Horizon Hill: Preliminary Plan No. 120120170

A request for three lots for three one-family detached dwelling units as part of a re-subdivision on 6.35-acres in the RE-2 zone; located at 10616 Red Barn Lane on the southwest side of Red Barn Lane in the 2002 Potomac Subregion Master Plan.

Staff Recommendation: Denial

Figure 3 - Proposed Lot Lines

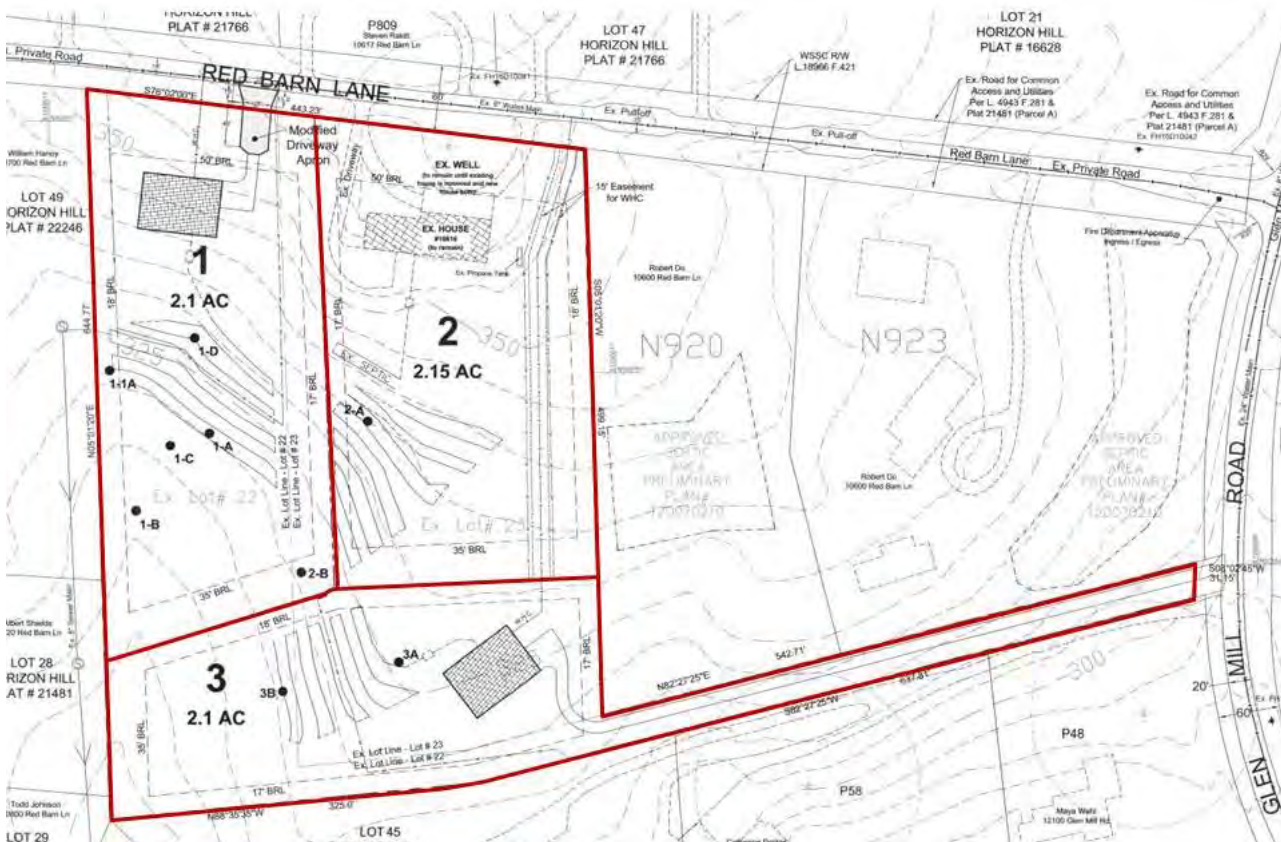
The Applicant proposes access to Lots 1 and 2 from Red Barn Lane, a private road, and Lot 3 would have access from Glen Mill Road, an exceptional rustic road. In 1990, (after the publication of the Proposal for a Rural/Rustic Roads Program and prior to adoption of the RRFMP) Plat 18005 depicted in Figure 9 was approved by the Planning Board stating “deny access to Glen Mill Road” from Lot 22, ostensibly to force the two lot subdivision to gain all access to Red Barn Lane. The note on the Record plat is a result

Staff does not support access for Lot 3 from Glen Mill Road. Staff believes there are several other options for the location of the driveway to Lot 3 that the Applicant has not evaluated and that should be analyzed. To date, the Applicant has been unwilling to submit information that would be required to analyze the impacts of a driveway for Lot 3, from Red Barn Lane.

Figure 9: Possible Driveway Alternatives

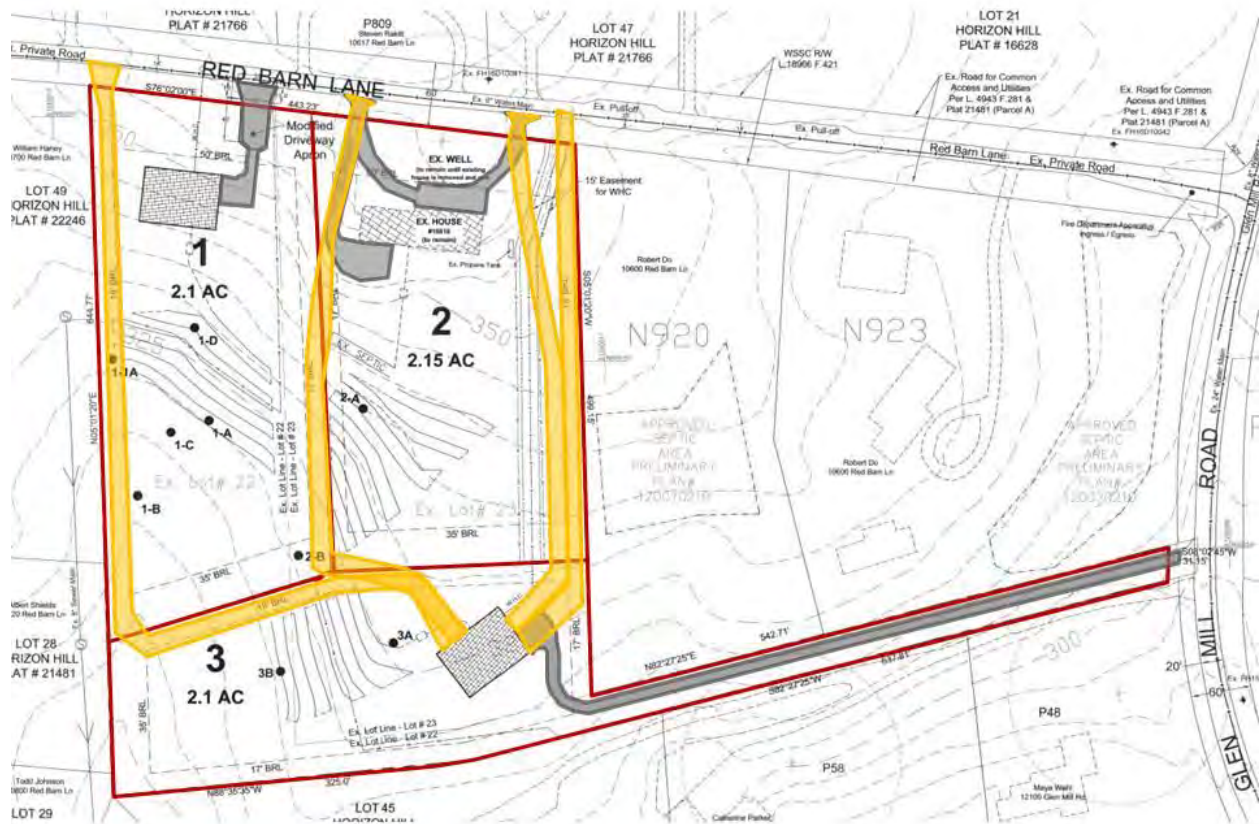
It is Staff’s position that the Applicant can access Red Barn Lane and still achieve the proposed density being requested. The threshold of considering an access point on Glen Mill Road an Exceptional Rustic Road has not been met since there are viable alternatives which would still achieve a three lot subdivision (figure 9).

As described in the Master Plan section above, Staff finds that the proposed subdivision does not substantially conform to the 2002 Potomac Subregion Master Plan or the 1996 Rustic Roads Functional Master Plan due to the negative impact the proposed Lot 3 driveway location will have on the Exceptional Rustic Road. There are multiple driveway routes to Lot 3 from Red Barn Lane that will not impact the Exceptional Rustic Road. (Figure 9).

Figure 10 - Plat 18005: Driveway access denied

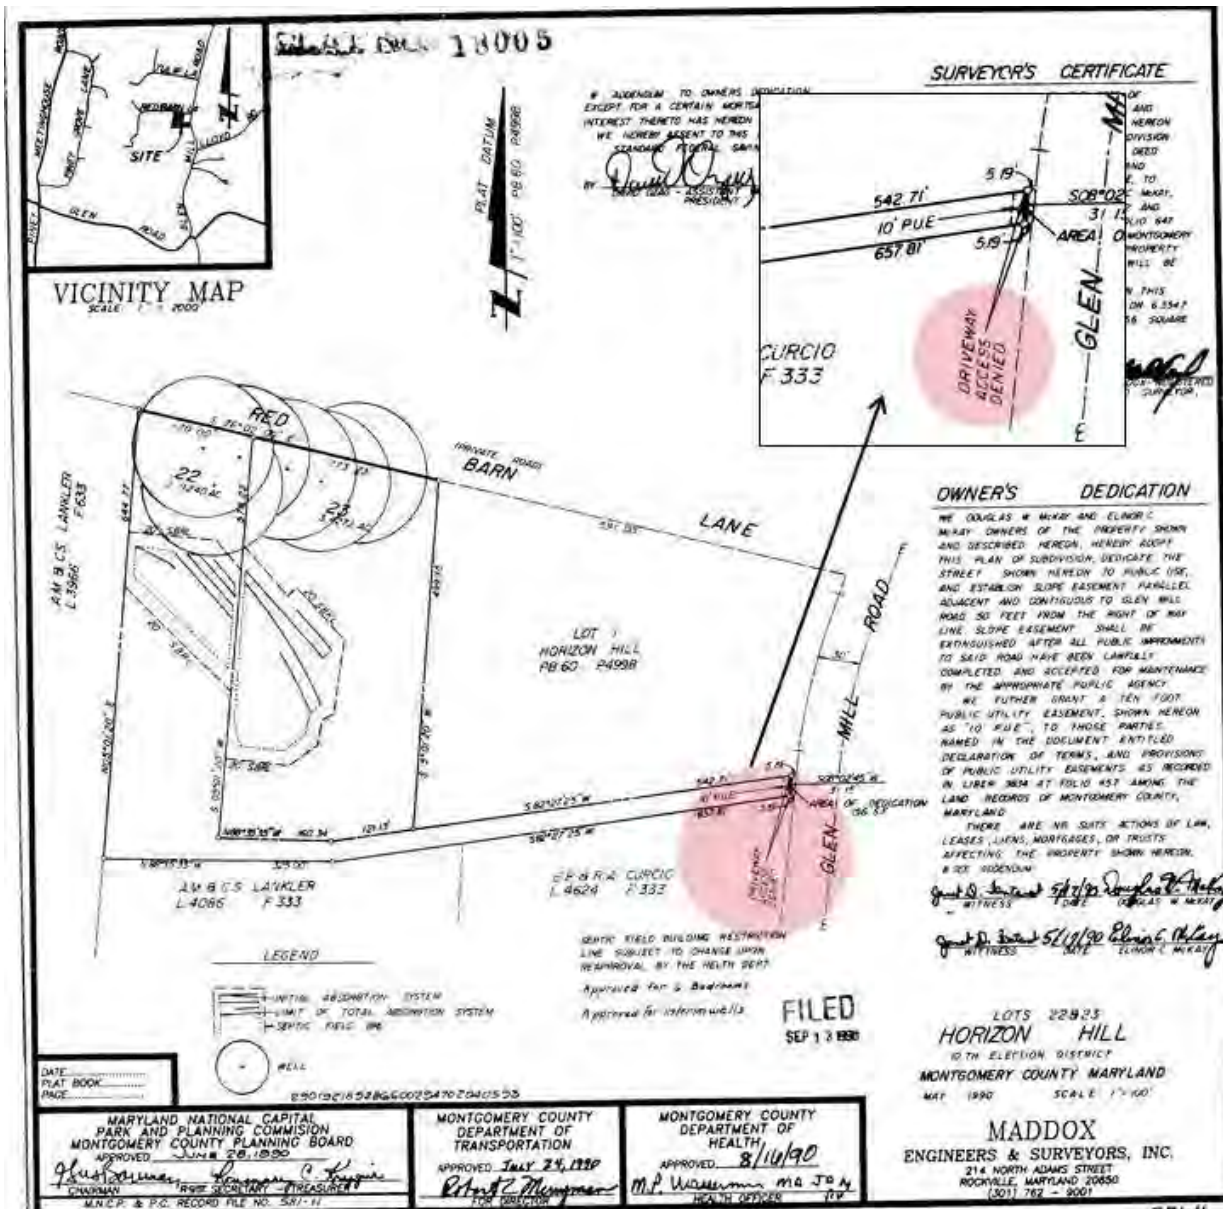
of Condition #3 of the Preliminary Plan Opinion #119892860 “No direct driveway access to Glen Mill Road” (Attachment H).

The previously approved Plat (#18005) currently restricts driveway access from Glen Mill Road. The construction of a new access point on Glen Mill Road will negatively impact the Exceptional Rustic Road. The RRAC, MCDOT, and Staff all recommend that the access for proposed Lot 3 be from Red Barn Lane and would only support access to Glen Mill Road if the Planning Board finds access to Glen Mill Road will not be a negative impact on an Exceptional Rustic Road. The Applicant has the ability to achieve the third lot with no impact to an Exceptional Rustic Road by accessing Red Barn Lane.

Figure 11: Proposed Variance Evaluated

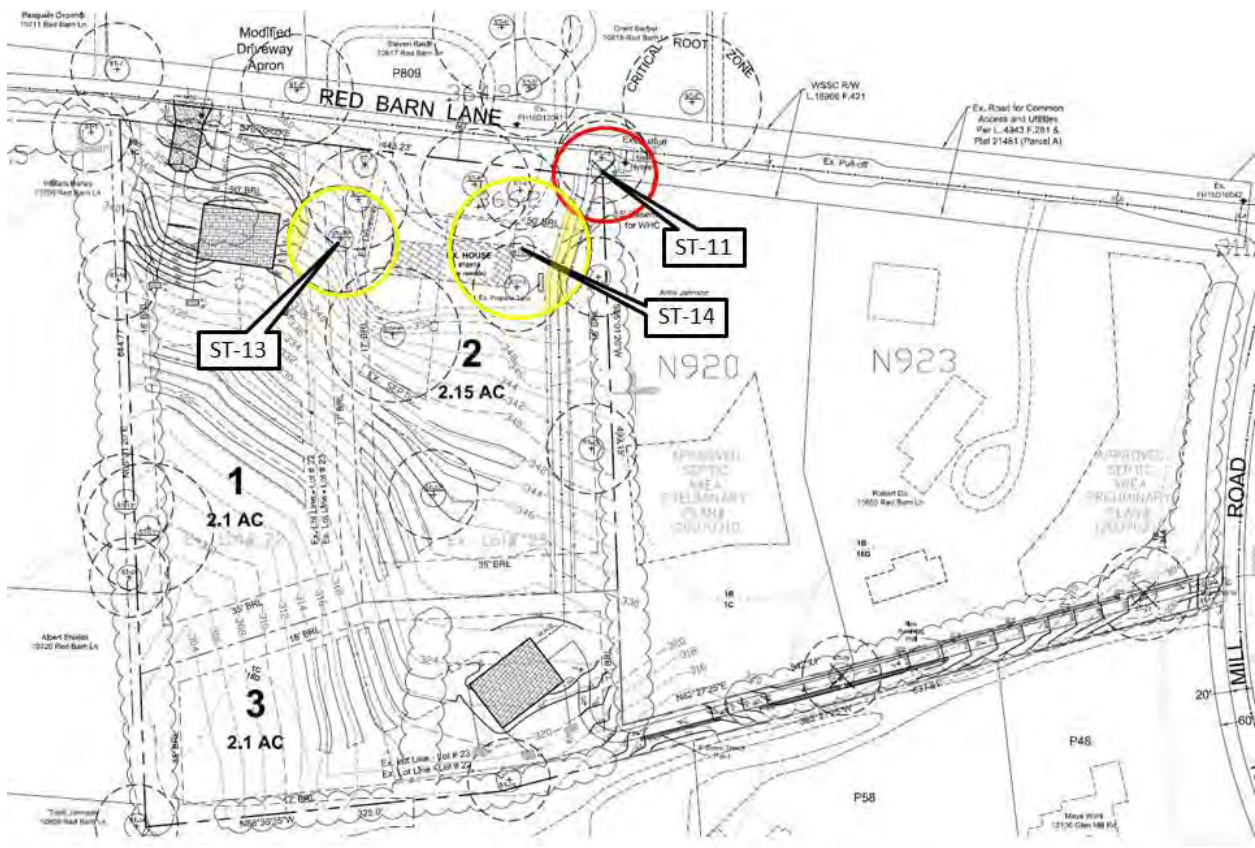
In October 2014, the Applicant made the initial variance request for the Subject Property. That request was revised several times but always included an analysis of impacts based on a driveway out to Glen Mill Road. The final version of the Variance was submitted on April 10, 2015 and requested impacts to two Protected Trees and the Removal of one Protected Tree.

Mitigation should be at a rate that approximates the form and function of the trees removed. Therefore, Staff is recommending that replacement occur at a ratio of approximately 1" caliper for every 4" DBH removed, using trees that are a minimum of 3" caliper size. For example, this means that for the 31" DBH of trees removed the Applicant should replace with 7.75 caliper inches of trees or three (3) 3" caliper size, native, canopy trees on the Property. While these trees will not be as large as the tree lost, they will provide some immediate canopy and ultimately replace the canopy lost by the removal of these trees.
